CITY COUNCIL AGENDA ITEM

Subject: ANNOUNCEMENT OF PUBLIC HEARING – PRELIMINARY SITE PLAN REVIEW (SP JPLN2021-0028) - Proposed Golden Villas One Family Residential Cluster, South side of Square Lake, West of Dequindre (PIN 88-20-12-200-031 & 88-20-12-200-035), Section 12, Currently Zoned R-1C (One Family Residential) District

Preliminary Site Condominium Cluster Review For City of Troy, Michigan

Project Name:	Golden Villas
Plan Date:	February 28, 2022
Location:	South of E. Square Lake, west of Dequindre
Zoning:	R-1C, One-family Residential District
Action Requested:	Preliminary Site Condominium Cluster Approval
Required Information:	Deficiencies noted.

DRAWING TITLE
**PRELIMINARY
SITE PLAN**

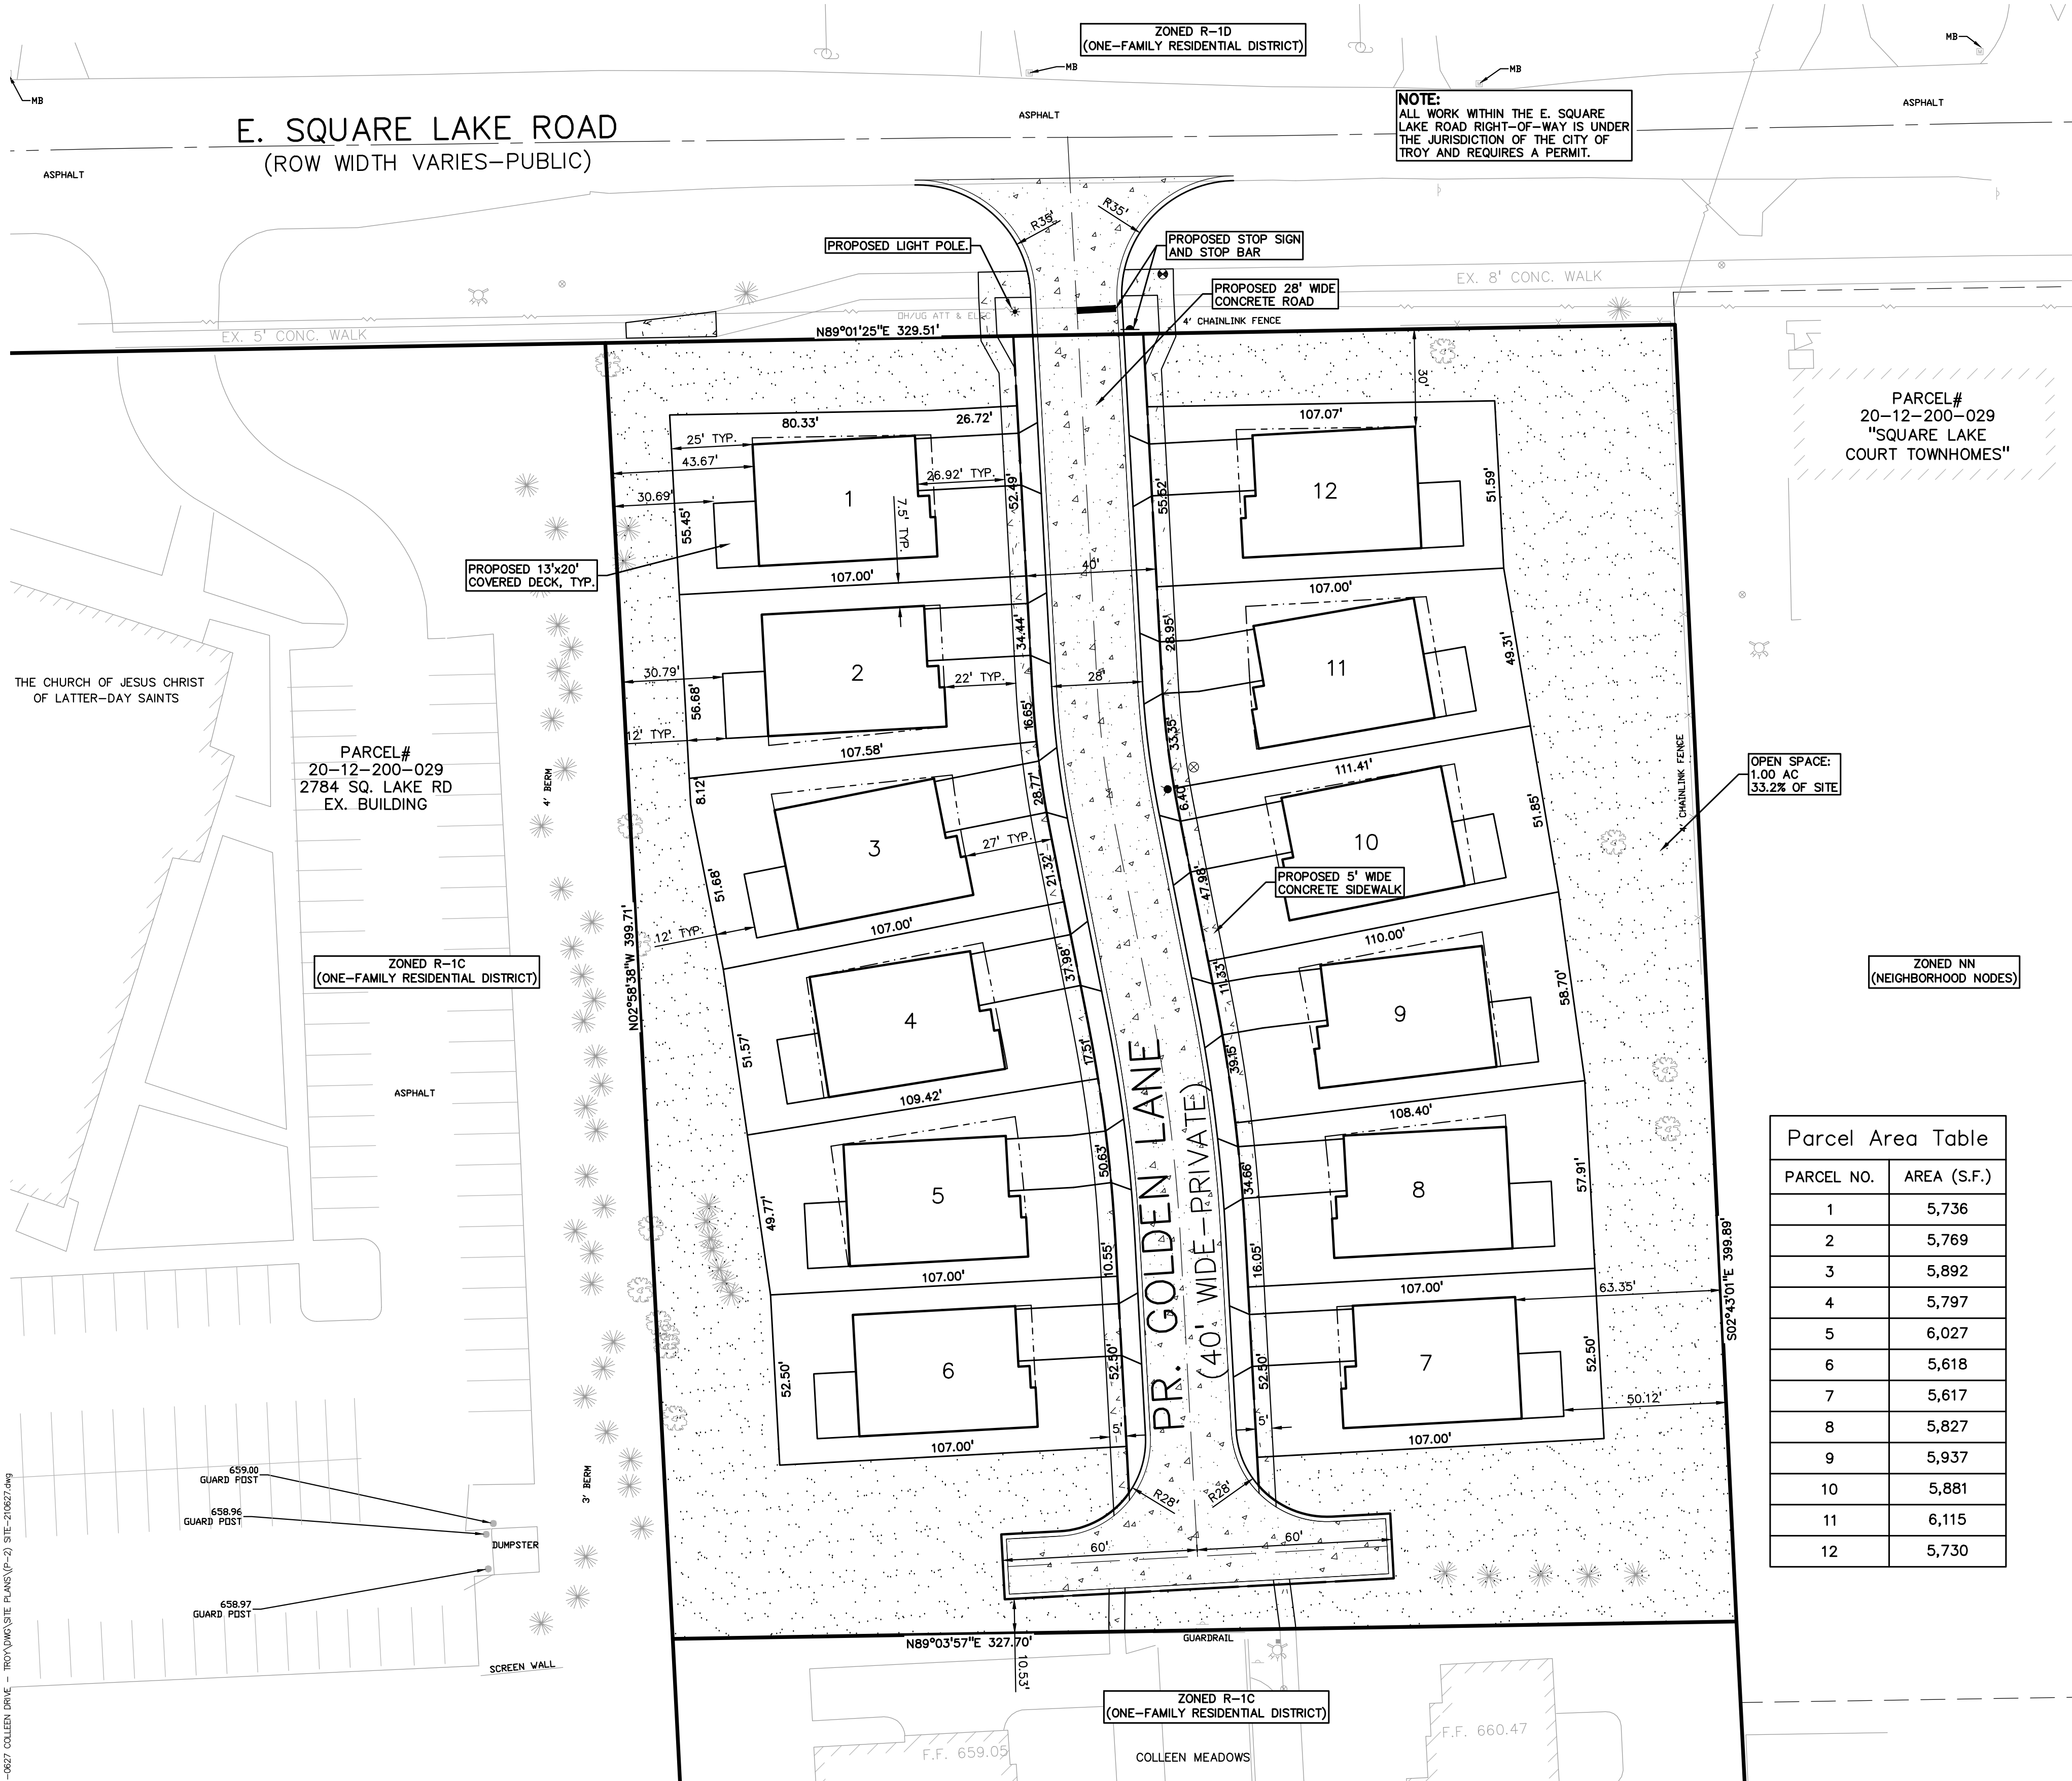
Rear Setback (building)	25-feet setback	25-feet minimum 10-feet with deck	Building envelopes comply. All decks encroach 15-feet into required rear yard. Applicant seeking relief to have minimum rear yard less than 25-feet due to deck.
Side Setback (building)	7.5-feet setback	7.5-feet minimum	Complies
Open Space Requirements: Minimum Percentage	20%	Proposing to preserve 1 acre of the 3 acre parcel, or 33%, for open space.	Complies. Applicant must submit open space preservation covenant.

Lots 1-3 encroach up to 10-feet into the required 40-foot perimeter setback. In addition, all decks extend 15-feet from home and encroach 15-feet into the required 25-foot rear yard. Please note that provision 7.08.B was drafted for a conventional R 1 through R-5 lot that requires a 40-foot setback. Hence for a typical R-lot, the 40-foot rear yard requirement would allow a 15-foot deck and still maintain at least a 25-foot rear yard setback. However, due to the required additional perimeter setback required by the cluster provisions, the decks are further away from the northern property line via cluster than conventional layout.

Items to be addressed: Consider the deck encroachment into rear setback and perimeter buffer

BE IT FURTHER RESOLVED, The Planning Commission recommends approval of granting relief from the required rear yard setback and required perimeter setback as per Section 10.04.E.5, as outlined in the report.

**PRELIMINARY
LANDSCAPE
PLAN**

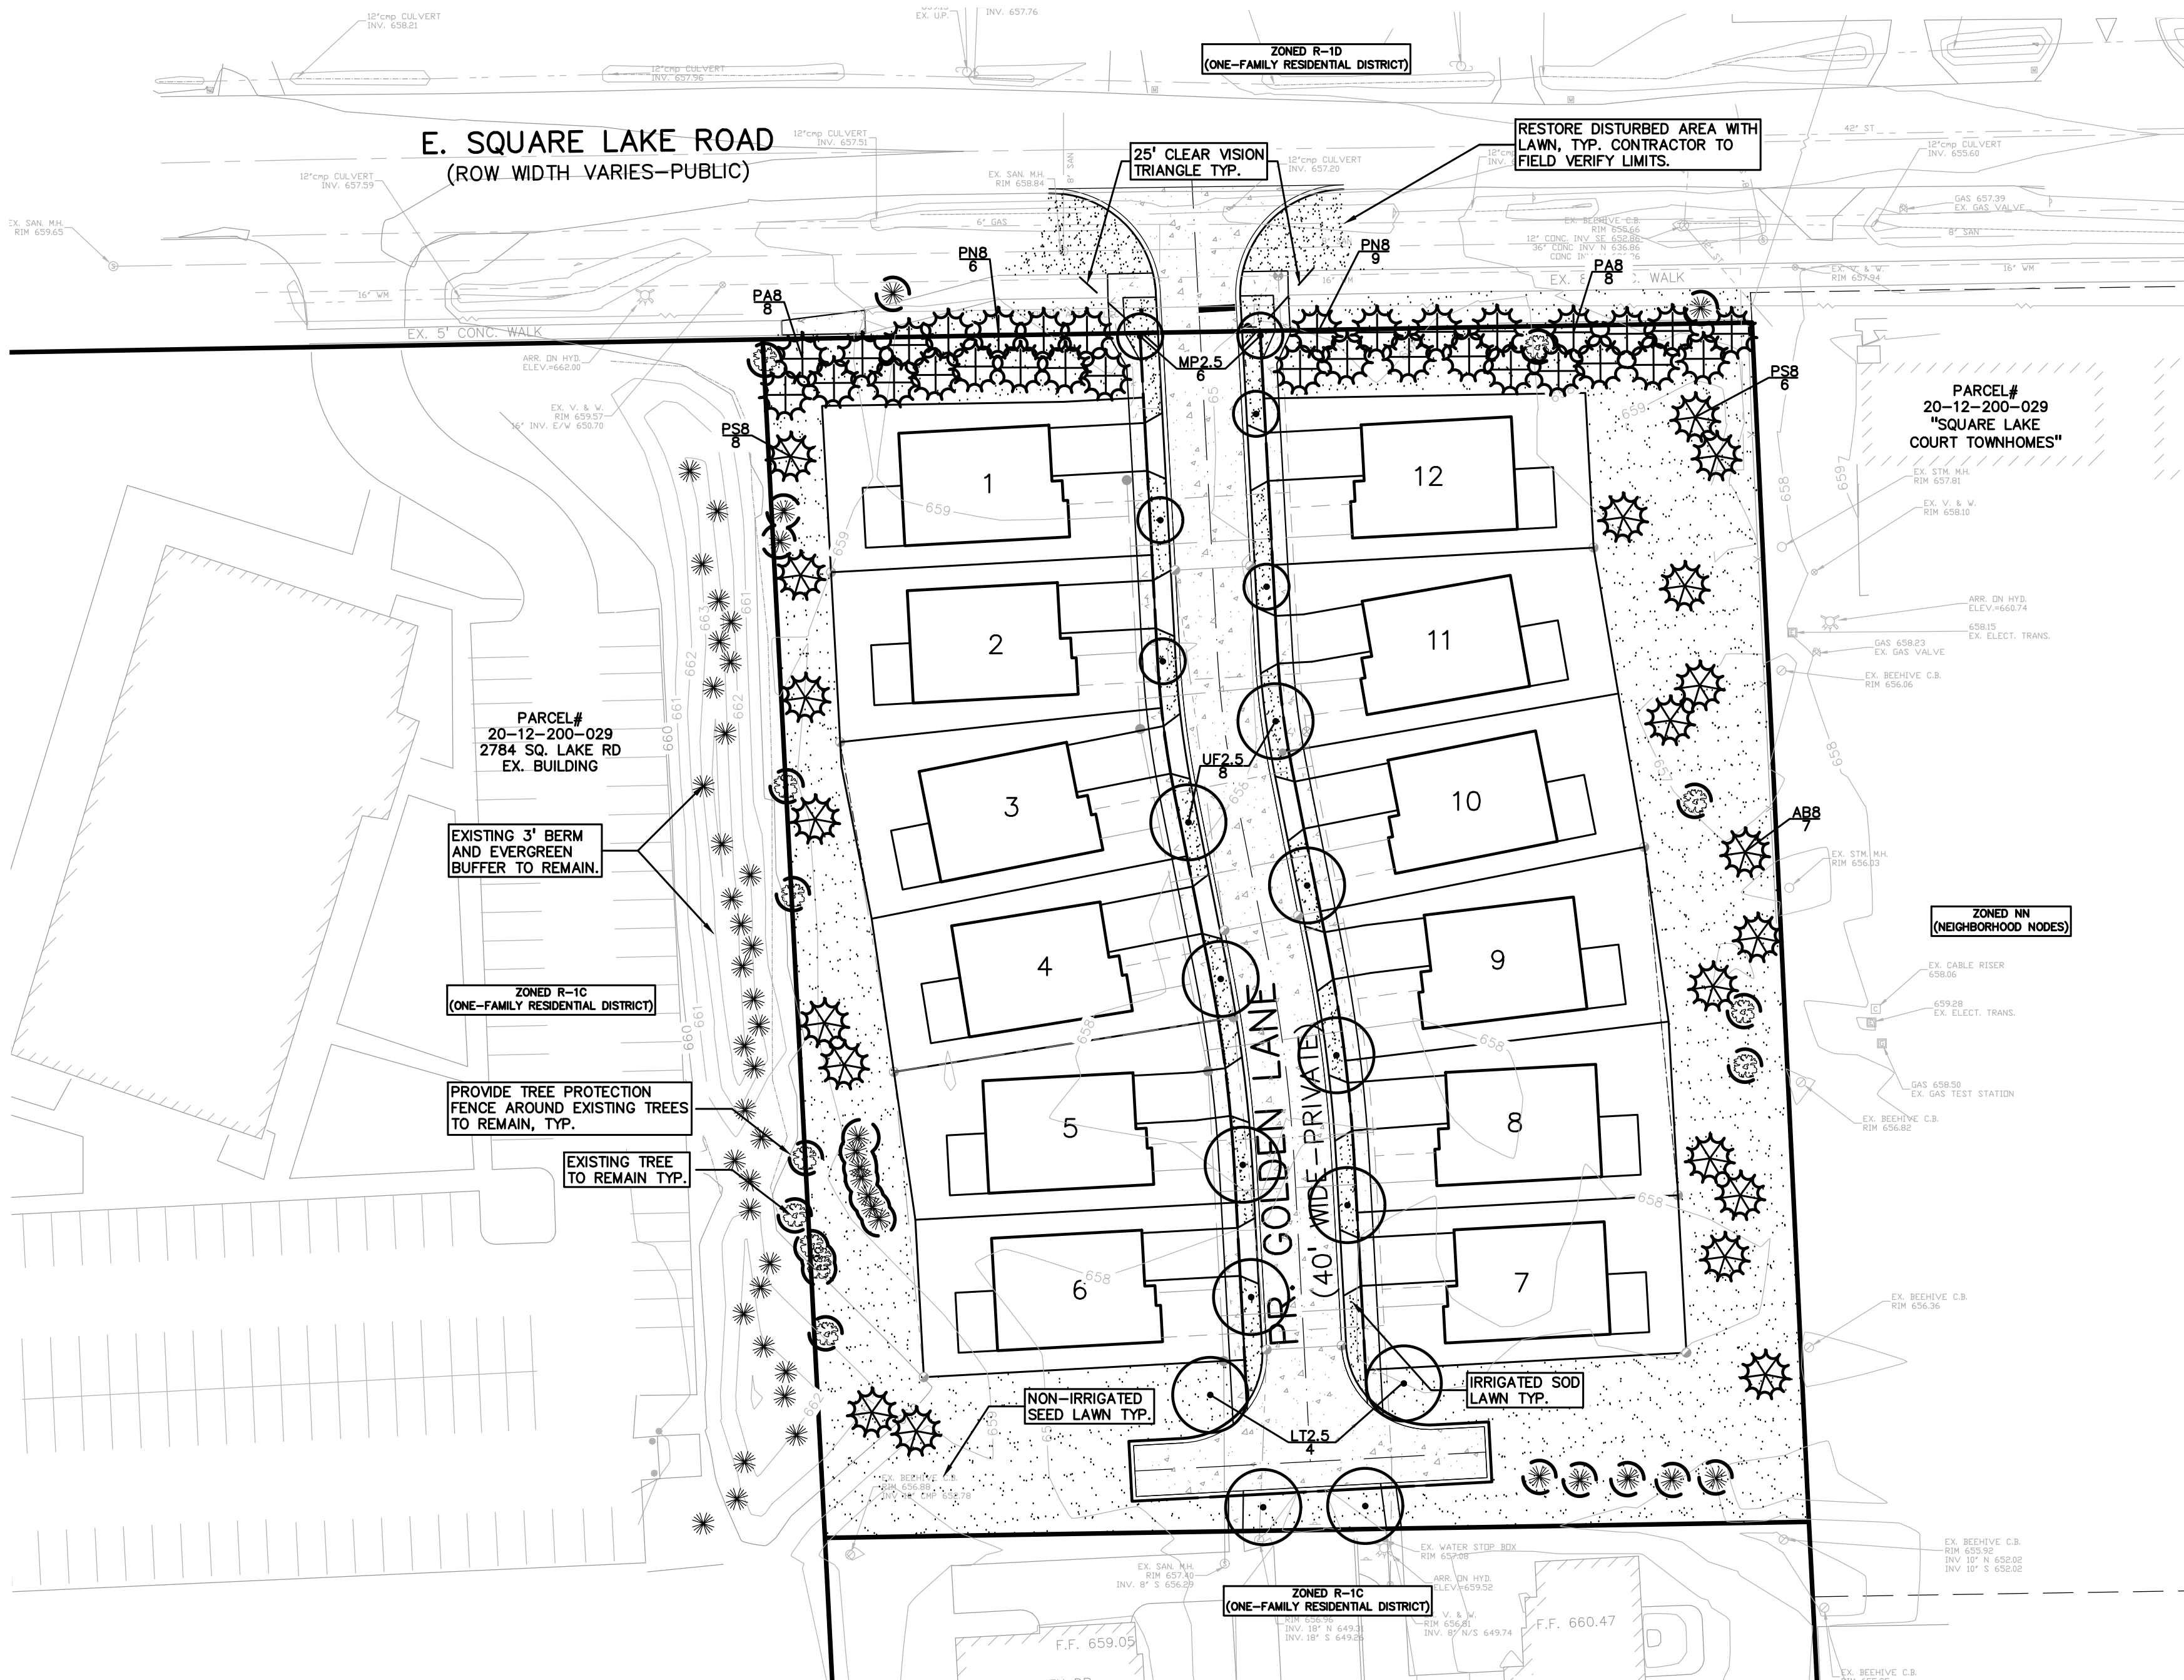
Frontage	Required	Provided	Compliance
Proposed Private Rd.	One (1) deciduous tree for every 50 lineal feet. $890 / 50 = 18$ trees	18 trees	Complies
E. Square Lake Road 120-foot ROW (section 13.02 F.2.c)	One (1) large evergreen tree per ten (10) lineal feet. $329 \text{ lf} / 10 \text{ lf} = 33$ evergreen trees	13 proposed	Does not Complies

The applicant is deficient of twenty (20) trees along Square Lake.

Items to be Addressed: Provide twenty (20) additional trees along Square Lake Road.

The petitioner submitted a Landscape Plan with the additional twenty (20) trees along Square Lake Road. The petitioner is required to provide a minimum of two (2) additional housing elevation options prior to submitting building permits, per Section 4.06.D.4. The petitioner has agreed that the exterior elevations will not include vinyl siding. An Open Space Preservation Agreement will be required to be submitted and approved prior to Final Site Plan Approval.
